ASSESSMENT REPORT			
Unique Document ID and Revision No:	ONR-OFD-AR-19-091 Revision 0	TRIM Ref:	2020/76467
Project:	Heysham 2 Reactor 8 2020 Periodic Shutdown		
Site:	Heysham 2		
Title:	Heysham 2 Reactor 8 2020 Periodic Shutdown: Structural Integrity Assessment of the Graphite Core Inspection Findings		
Nuclear Site Licence No:	588		
Licence Condition(s):	30, 28		
ONR Assessment Rating (Mandatory): <i>(Rating should be based on licensee's original safety case submission)</i>	GREEN		
COIN Service Order:	N/A

**Heysham 2 Reactor 8 2020 Periodic Shutdown – Structural Integrity Assessment of the
Graphite Core Inspection Findings**

Assessment Report ONR-OFD-AR-19-091
Revision 0
25th March 2020

Figure 1: Doubly cracked brick with two full height axial cracks and one partial axial crack in Channel D77, Layer 6.

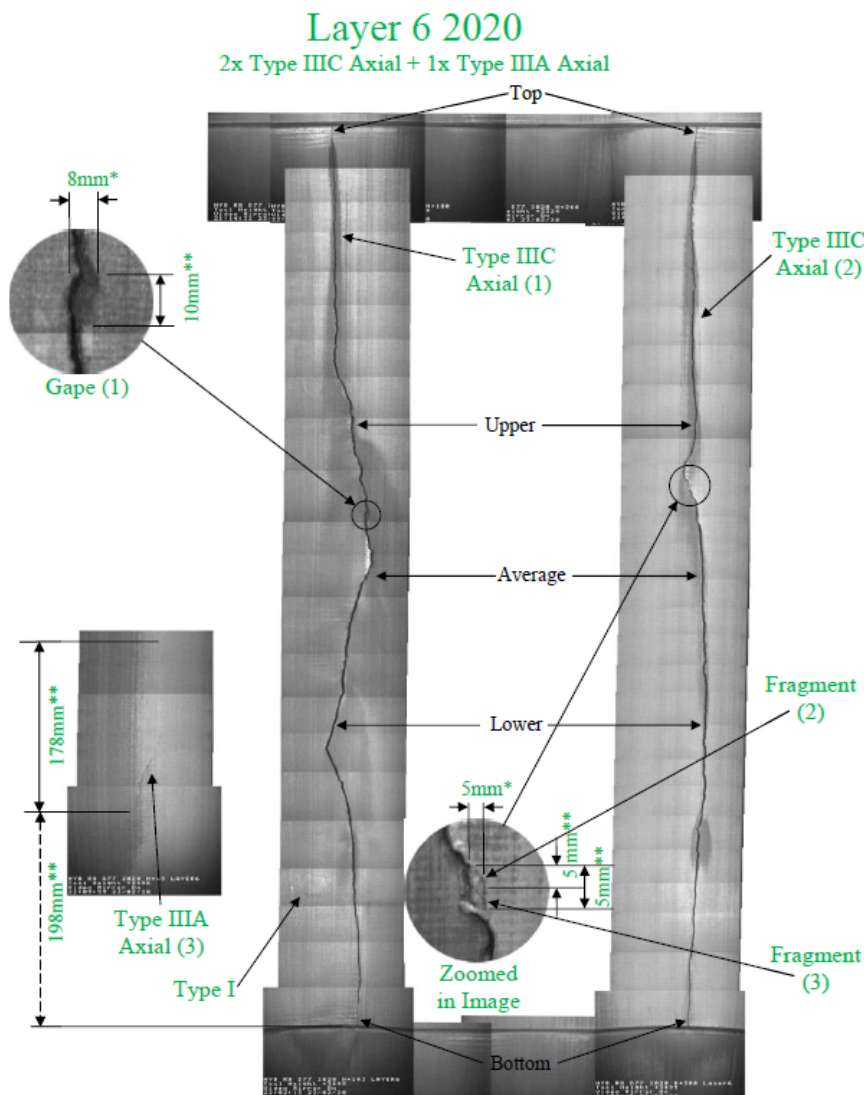
53. Two full height axial cracks and a third smaller axial crack were found in the channel D77 Layer 6 brick; see Figure 1. This was the first inspection of the channel since first commissioning of the plant.

57. In my view, the morphology and the tortuosity of the cracks are consistent with bore-initiated cracking. 'Lipping in', characteristic of bore cracking, is also evident from the measurements, as shown in Figure 2. I therefore agree with the conclusions from the GAP that the cracks are likely to have initiated from the channel bore earlier in the life of the reactor.

59. In my opinion, the smaller partial height crack visible in Figure 1 is unlikely to grow to a significant extent by the same damage mechanism as bore cracking is considered to be an early life damage mechanism.

60. The bore measurements from channel D77 were within expectation and do not show any sign of significant displacement due to the presence of the cracked brick in layer 6. Although the GAP assessors highlighted 3 fragments in Figure 1, I do not consider that these would be significant if these were to become detached.

62. However, the PAR should note that a doubly cracked brick was observed in channel D77 layer 6. NGL should consider whether this channel should be re-inspected in future fuel channel inspections (Recommendation 3).

Figure 2: Bore measurements of fuel brick in channel D77, layer 6.

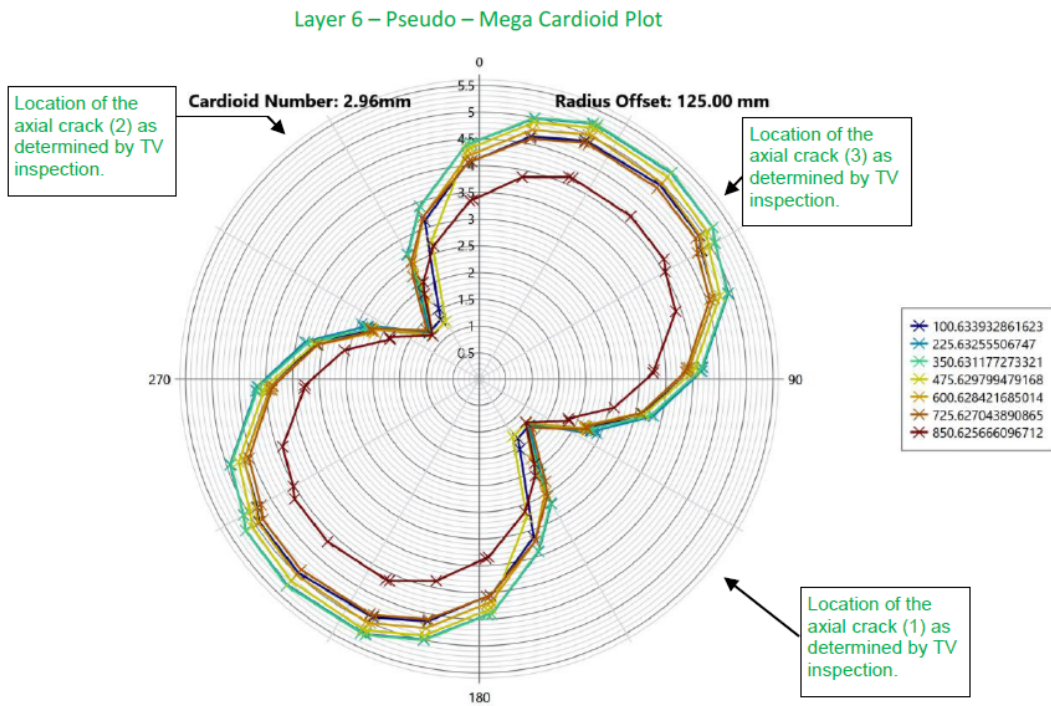
61. Overall, the graphite inspection findings were broadly within expectation. The bore measurements show that the channel distortions remain small and do not challenge the safety case assumptions. In my view, the number of cracked bricks in the core is below the level of cracked bricks that could challenge the safety case. I am content that the presence of the doubly cracked brick in channel D77 does not undermine this conclusion. The findings of the fuel channel inspections are therefore acceptable.

Figure 3: Cracked brick in Layer 4 of Face 15, Brick No. 2 (top of the brick).

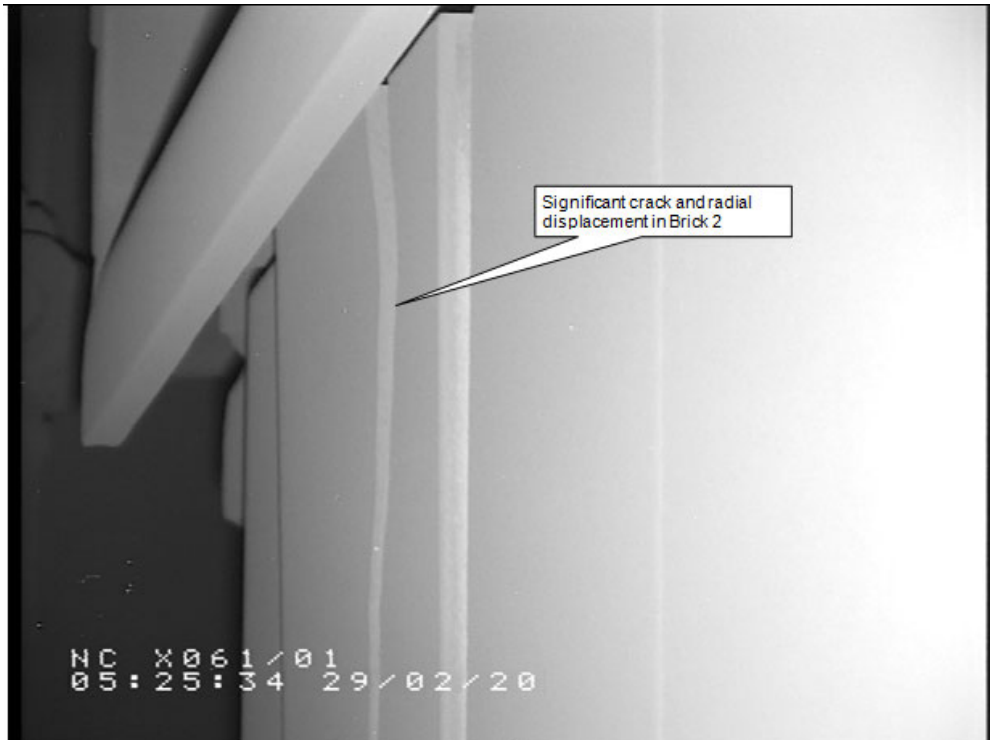
72. Reviewing the result of this inspection, the PBAP noted that:
- the crack has significant separation particularly at the top of the brick;

- there is significant radial misalignment, particularly at the top of the brick and the left-hand side of the brick appears to be leaning outwards and potentially resting on the upper restraint beam;

- the adjacent bricks do not appear to be cracked or displaced.
73. The PBAP considered the significance of this defect with respect to the safety case. The following aspects were considered: the stability of the brick, the thermal consequences of a missing brick and debris. NGL noted that no missing bricks had been observed and that it was unlikely that any brick section had become dislodged. NGL concluded that the consequences with regard to re-entrant flow remain and debris would remain acceptable and are covered by the existing safety case (Reference 3).

74. In my view, the gapping would not be sufficient to cause a significant bypass of the coolant flow. Similar 'leaning' bricks have been found previously in the TOR reactors. The consequences of cracking are therefore considered in the existing safety case (Reference 3). In my opinion, the PBAP's judgement with regard to this brick seems appropriate. I am therefore of the view that NGL's conclusions are acceptable.
